**SAN ANTONIO WATER SYSTEM
WECO DISINFECTION SYSTEM- SAWS
SAWS Job No. 14-6004
Solicitation No. CO-00025**

ADDENDUM NO. 1

April 8, 2016

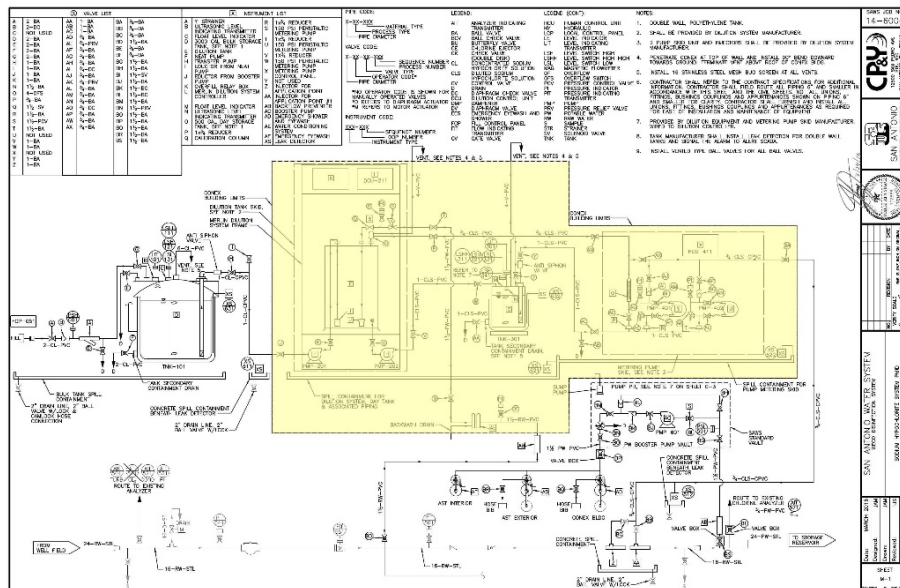
1. Question: I am unable to locate a physical address for the work site in the specs or plans. Is there an address?

Response: The recorded address for the project site is 19001 Blanco Road, San Antonio, TX 78258. However, the project site is accessed from Huebner Road. See page 4 of this Addendum for a map view of where the project site is located in reference to Huebner Road.

FIGURE 1

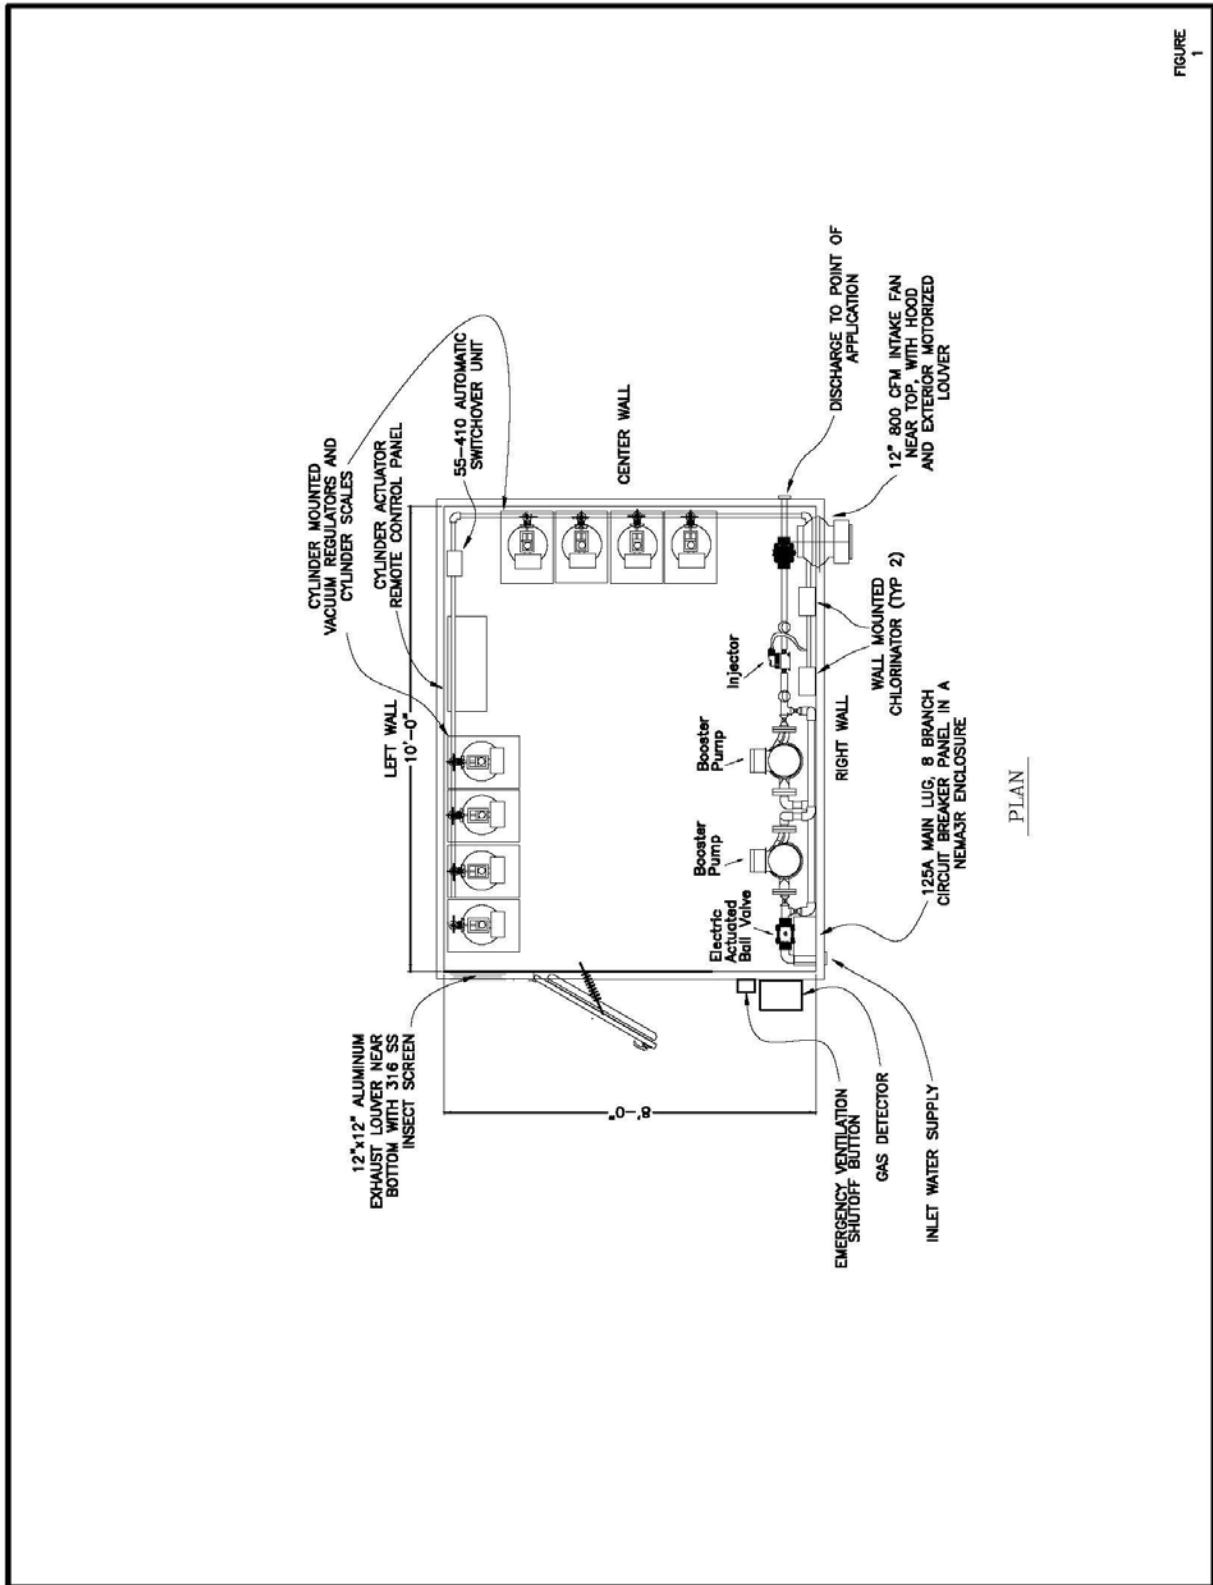
- D. Refer to Figure 1 and Figure 2 at the end of this specification for the layout of the equipment within the 8' x 10' FRP building.
- E. The system shall deliver a chlorine solution to the designated point of application as shown on the plans and be housed in a fiberglass reinforce building.

FIGURE 2

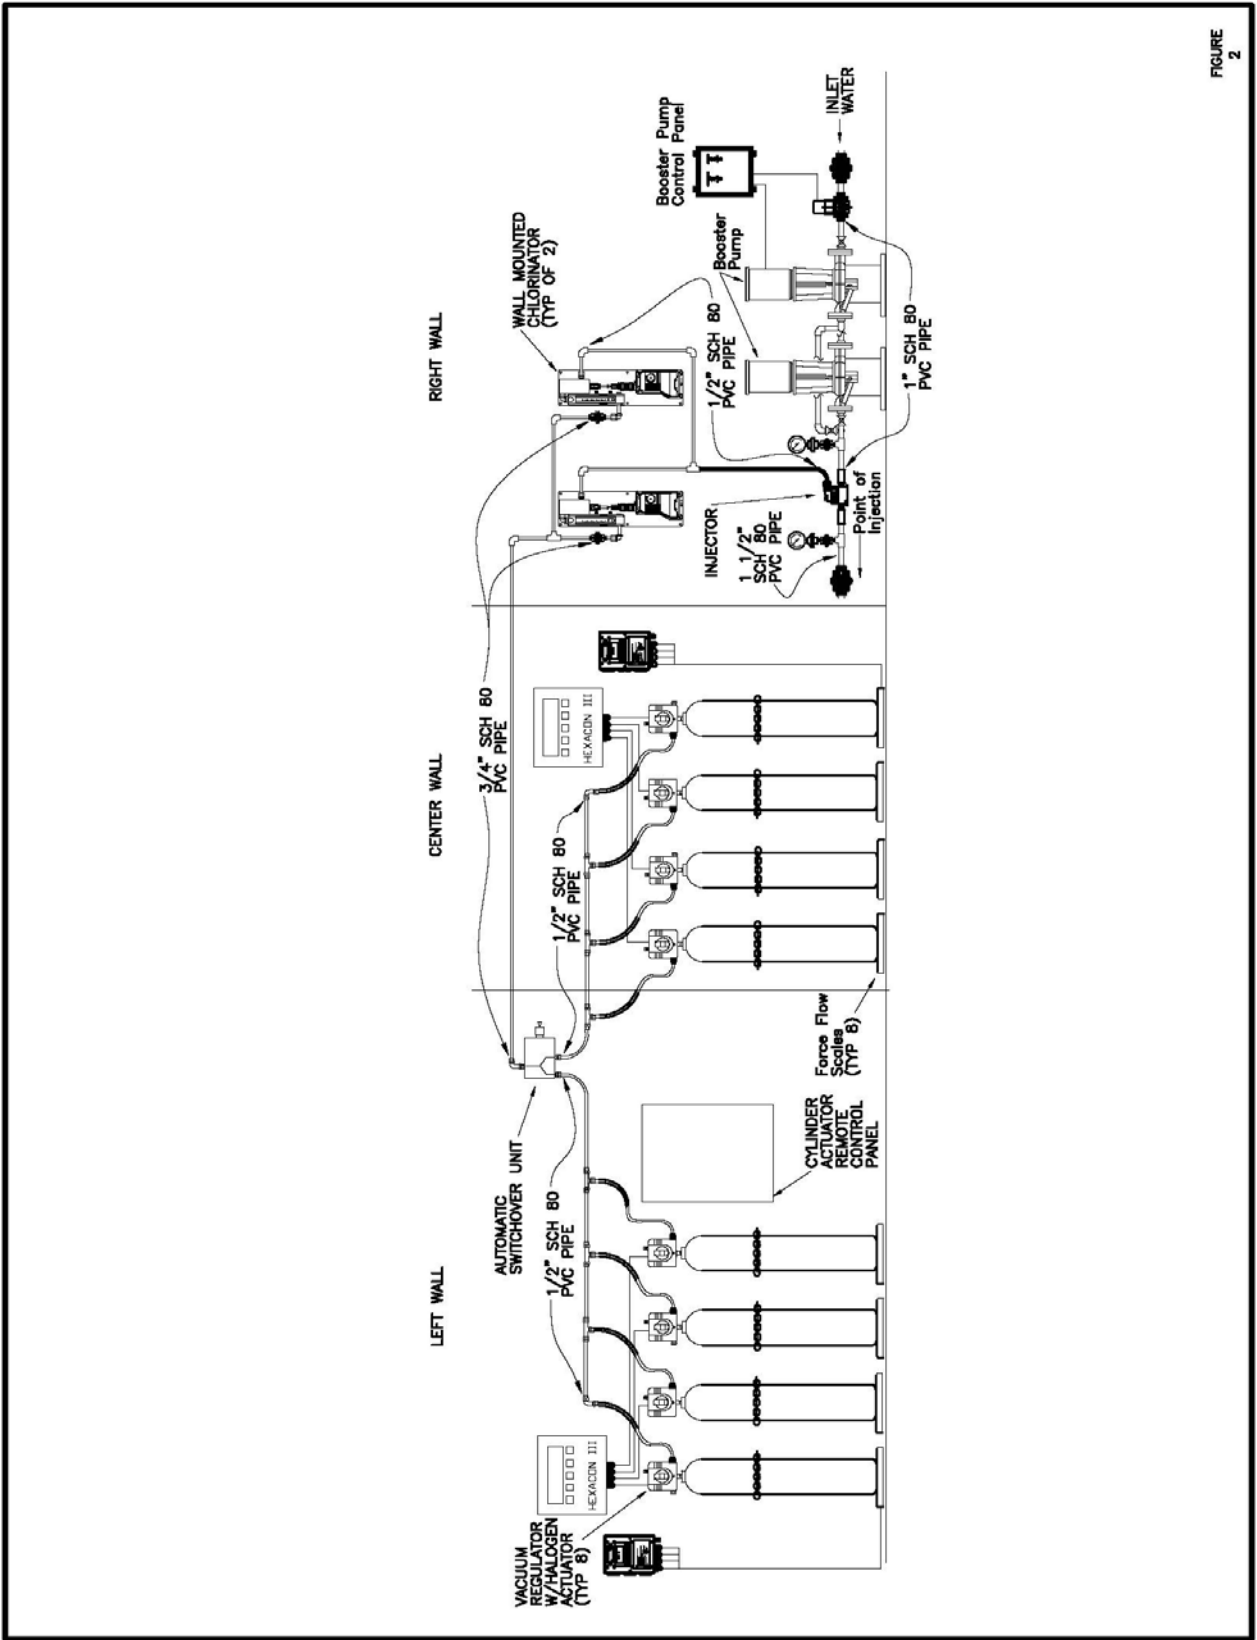
- A. Piping shall be threaded Schedule 80 PVC. Sizes shown in Figure 2 provided.
